QUALITY ASSURANCE -- NON-CONFORMANCE REPORT

Report No: NCR-000325

Reference Description: Missed MT Indication by QC, Base Metal of Deck Panel DP009A, Segment 3AW

Job Name: SAS Superstructure

项目名称 Project Name	美国海湾大桥 SFOBB	部件图号 Drawing No	SEG020B/SEG018C	报告编号 Report No.	B-WR7354
合同号 Contract No.:	04-0120F4	部件名称 Items Name	4E PLATE PANEL SPLICE	NDT报告编号 Report No.of NDT	B787-MT-13624
项目编号 Project No.:	ZP06-787

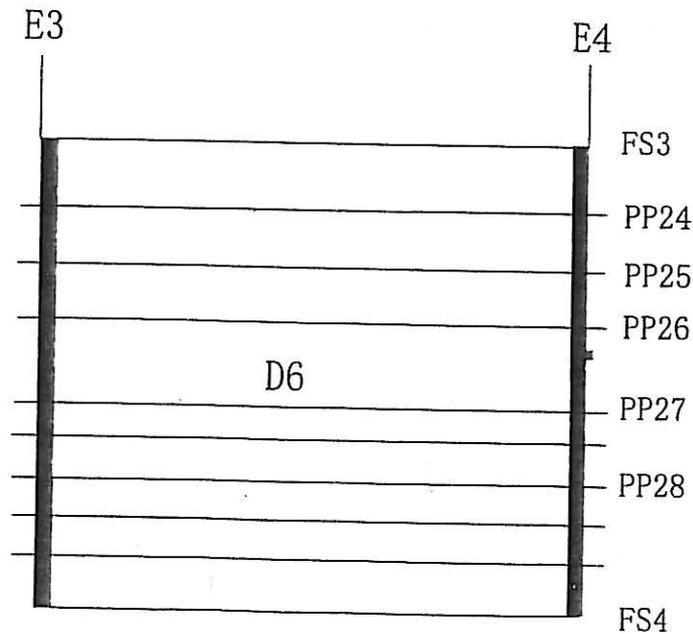
One line indication was found by use of MT on weld SEG020B-008. L=20 Y=0

One line indication was found by use of MT on weld SEG018C-026. L=30 Y=0

1. 焊道未及时处理干净。
1. Did not clear the weld pass completely in time.

1. 按照焊接返修工艺规程 (WPS) 打磨缺陷区域;
 2. 按照返修WPS准备焊接破口;
 3. 返修前对进行返修的区域作100%MT检查, 确保缺陷全部去除;
 4. 根据批准的焊接返修工艺规程 (WPS) 进行预热及焊接;
 5. 将焊接区域打磨至与周围母材平齐;
 6. 对修补区域进行VT与MT检测;
-
1. Remove all the defects according to the approved repair WPS by means of grinding.
 2. Prepare a groove based on the repair WPS.
 3. Verify with MT and VT no defects remain in the repair area prior to welding;
 4. Preheat and weld according to the relevant WPS.
 5. Grind the weld flush with adjacent base metal after welding.
 6. Perform VT and MT inspection to the repaired area.
